# OHIO HISTORIC INVENTORY

**2. BSD HR – Vessels' Residence  
18-073ARB/MPR**

**63 S. Riverview Street  
Minor Project Review**

**2. BSD HR – Vessels Residence  
18-059ARB-MPR**

1.No. FRA 2547-1		2.County FRA		4.Present Name(s)  <input checked="" type="checkbox"/> CODED <input type="checkbox"/> CODED	
3.Location of Negatives City of Dublin		5.Historic or Other Name(s) Kilbourne/Sandy/Eberly Residence			
Roll No. Picture No.(s) 2 8

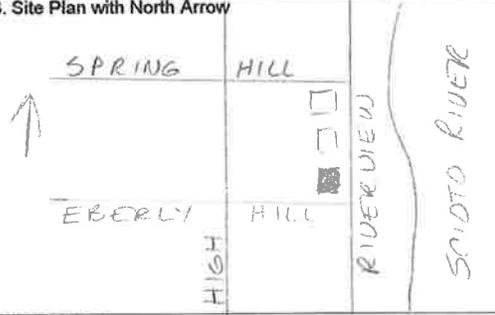
42. Further Description of Important Interior and Exterior Features (Continue on reverse if necessary) Small cottage with gabled roofline. The shingle siding on the house in the 1976 was replaced with wood siding that looks like stone. Other alterations include new 8/8 windows. A two story addition and a single story wing are both located at the rear.				 PHOTO
